Black Fork Wind Energy, LLC Element Power US, LLC Case # 10-2865-EL-BGN

Testimony of Thomas Allen Karbula Sr.

Exhibit G1

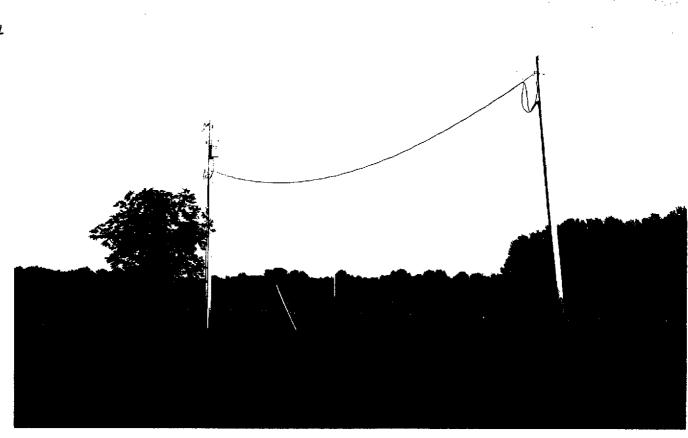
(Exhibit G, Staff Report of Investigation, pg 35, Shadow Flicker)

Paragraph 4, lines 1 and 2 state, ""Realistic" conditions based on the turbines' operational time, operational direction, and sunshine probabilities were used to calculate a realistic amount of shadow flicker to be expected at each shadow receptor. The Applicant simulated shadow flicker from the proposed turbines out to one kilometer (3,280 feet)." The said named turbines, 85, 86, 87, 88, are all going to be completely visible from my residence. I'm including four pictures of the areas where these turbins are to be located. Turbin #86 I have labeled as (Exhibit G1). Turbin #85 I have labeled as (Exhibit G2). Turbin #88 I have labeled as (Exhibit G3). Turbin #87 I have labeled as Exhibit G4. The furthest turbine is roughly estimated to be 1,700 feet from the center of my property from your provided maps. How many flicker hours over 30 per year will my residence receive?
